Recall Bulletin

SUBJECT: Loss of Battery Charge – Inspect Generator Control Module

MODELS: 2012-2013 Buick LaCrosse, Regal
2013 Chevrolet Malibu Eco
Equipped with eAssist

The Part Inspection Procedure in this bulletin has been revised. Please discard all copies of bulletin 13136B.

3600552

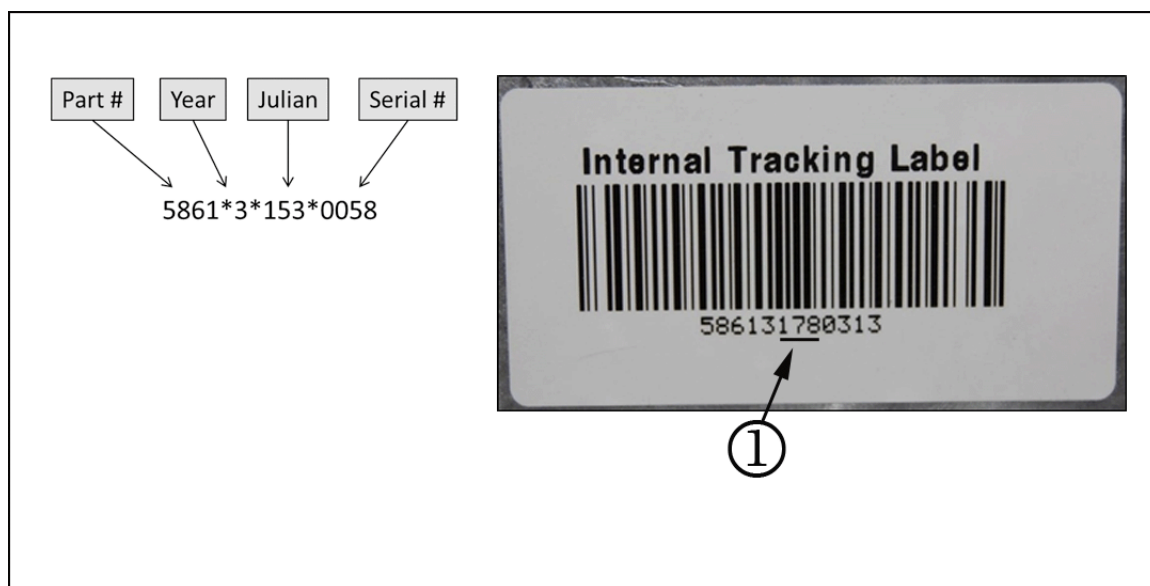
Do NOT provide technicians with GCMs (p/n 24269448 or 24266403) that have a Julian date of 171 through 199. Determine the Julian date following the steps below. Return modules that fail the inspection according to Special Return Bulletin #G_0000171850.

1. Locate the barcode label on the new GCM.

2. Determine the Julian date (1) as shown above.

- If the Julian date (1) is 171 through 199, proceed to step 3.
- If the Julian date (1) is NOT 171 through 199, provide the GCM to the technician for installation in the vehicle.

3600552

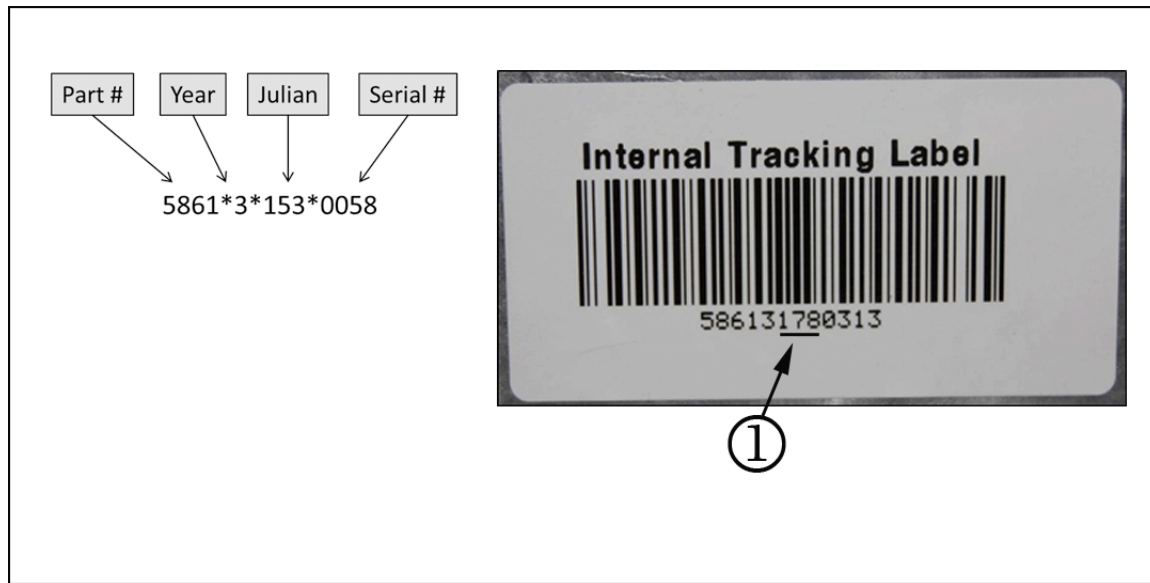
1. Locate the barcode label on the new GCM.
2. Determine the Julian date (1) as shown above.
 - If the Julian date (1) is 171 through 199, proceed to step 3.
 - If the Julian date (1) is NOT 171 through 199, install the GCM in the vehicle.

3. Locate the Flash label on the GCM.
 - If the number on the lower right-hand side of the label (2) is 3203 or lower, do NOT use the GCM. Obtain another module and perform the inspection again.
 - If the number on the lower right-hand side of the label (2) is 3204 or higher, install the GCM in the vehicle.
